**HISTORIC LANDMARK COMMISSION
STAFF REPORT**

**31 E Hillside Avenue
New Construction-Single Family Dwelling**

**New Construction- PLNHLC2015-00224
Special Exceptions- PLNHLC2015-00281**

Meeting Date: May 14, 2015

6 Elevation
A2.50 Scale: 1/4" = 1' - 0"

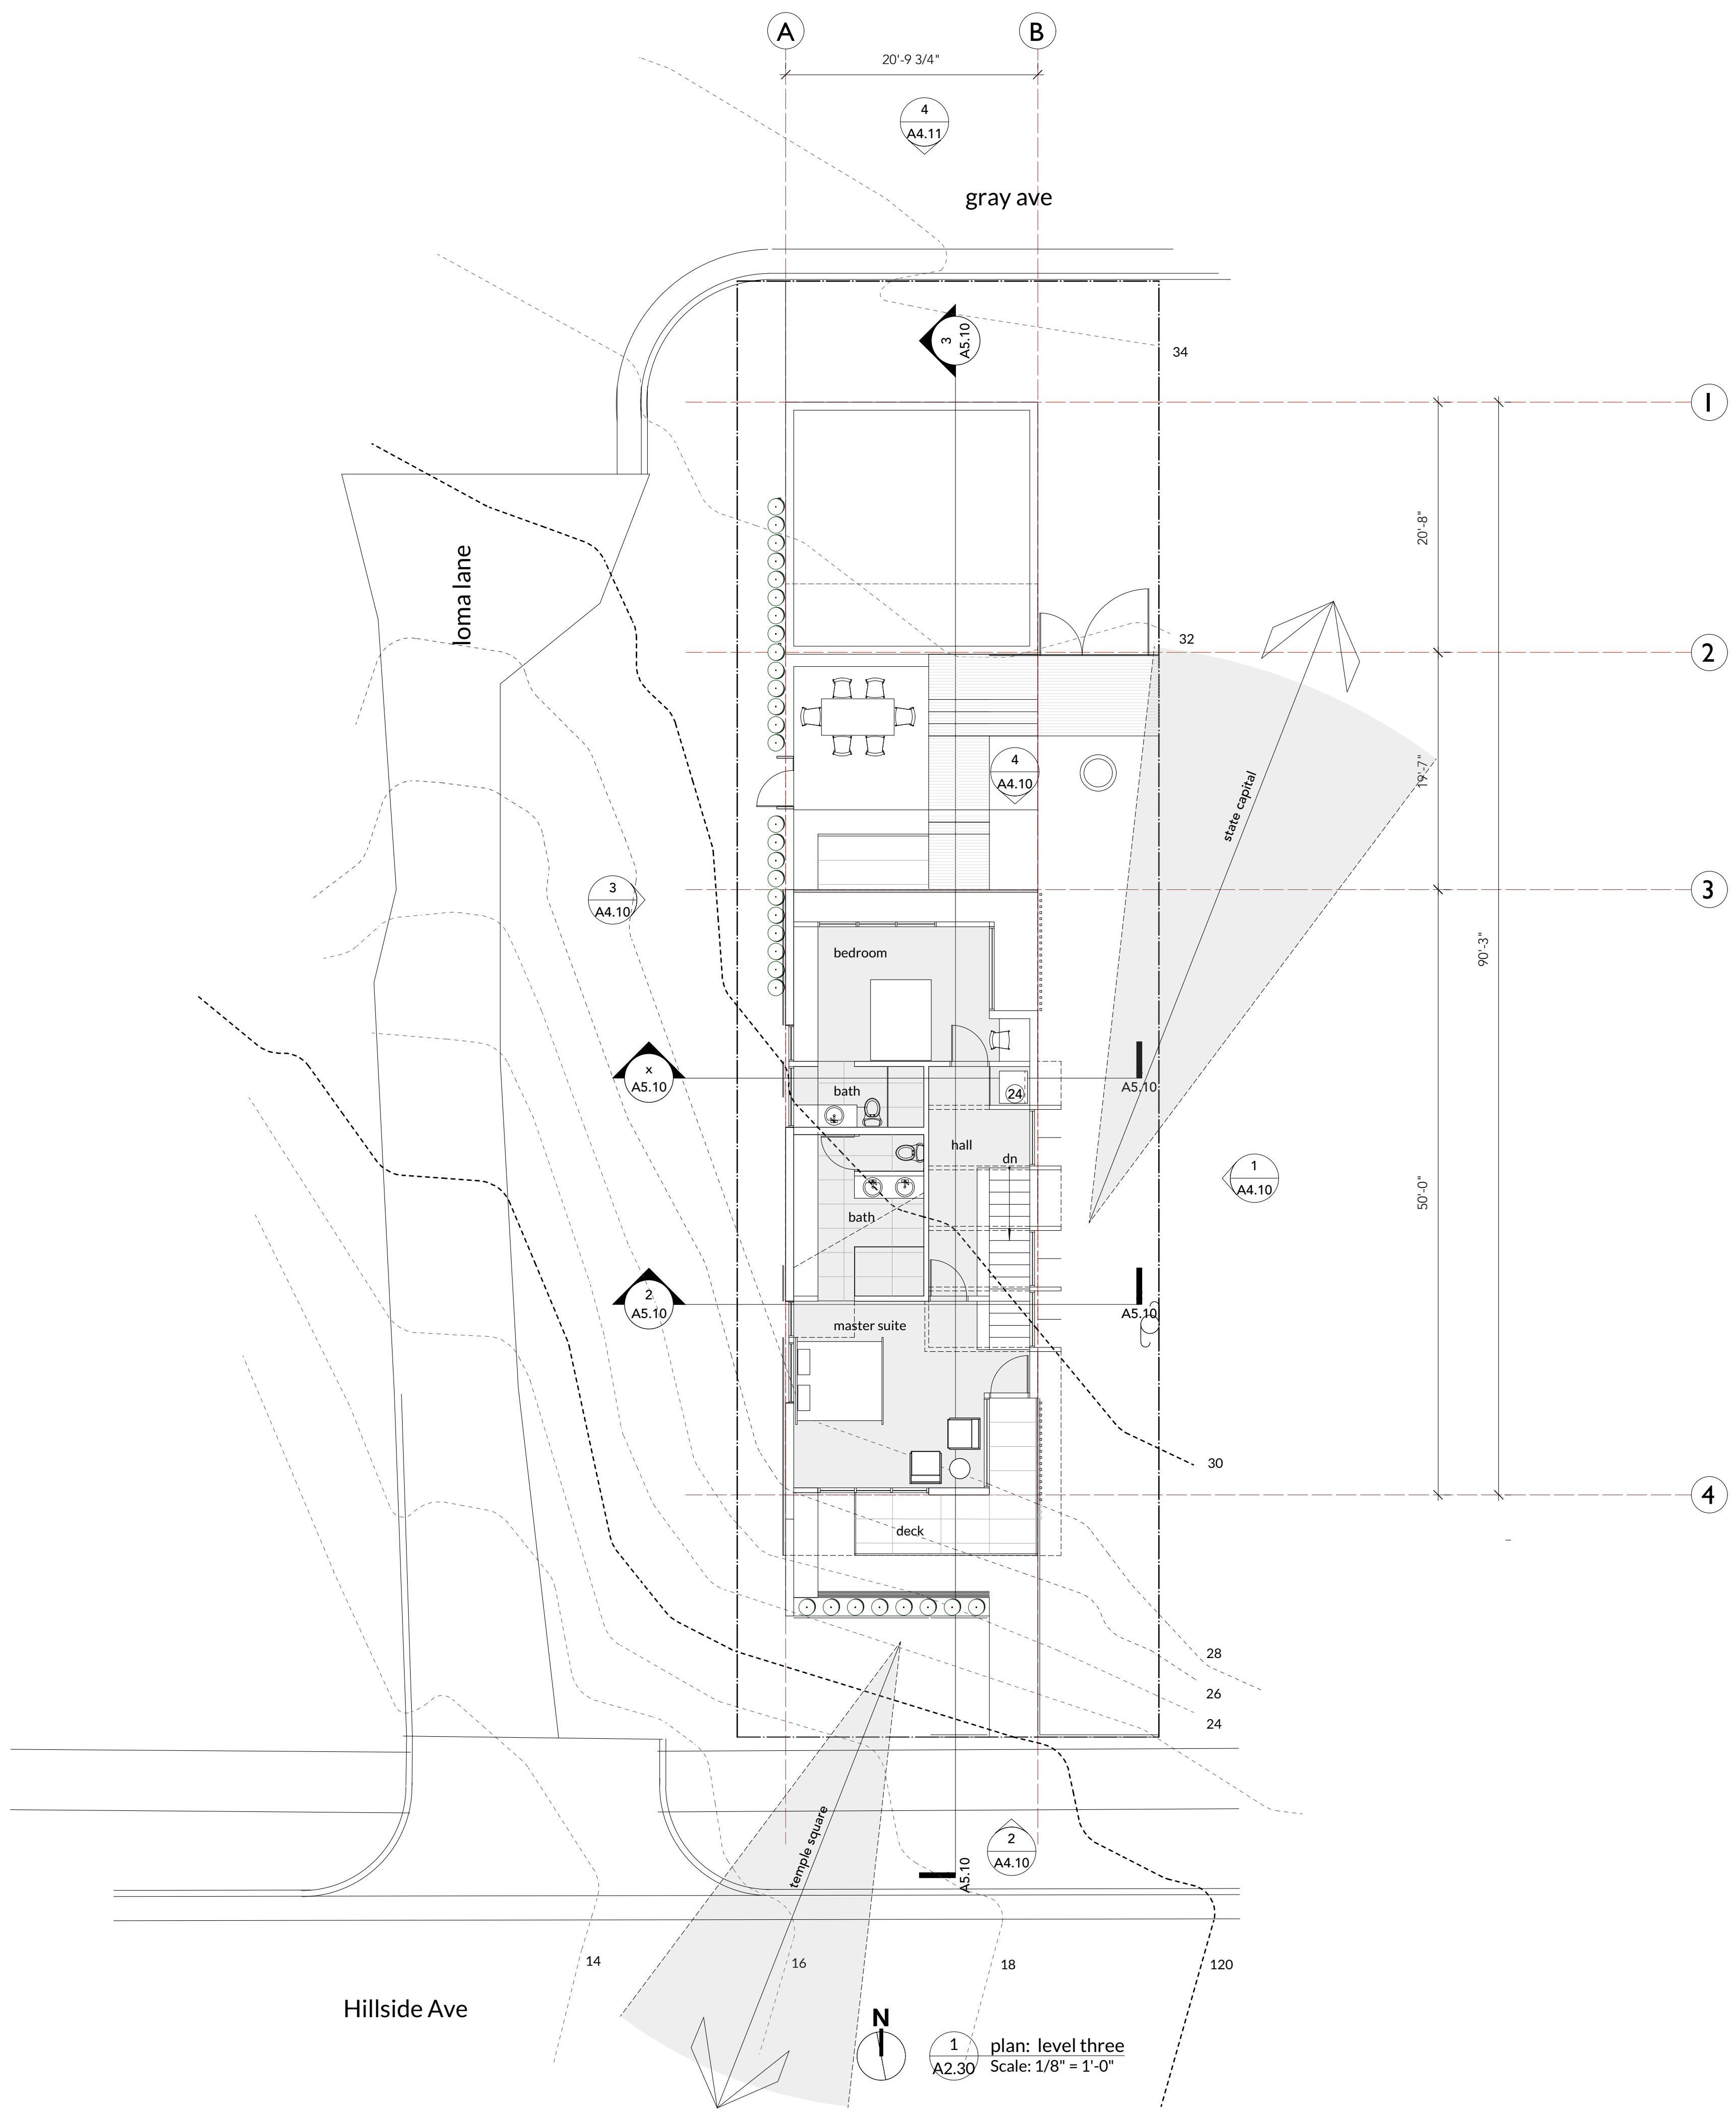
3. **Grade Changes:** In order to accommodate the construction of the proposed single-family home, grade changes in excess of 4 feet (4') are proposed in the corner side yard and the front yard area to accommodate a walk in basement and window wells for the property. The highest point of grade change is approximately 5 feet 5 inches (5'5"). (See Attachment A sheet A2.50)
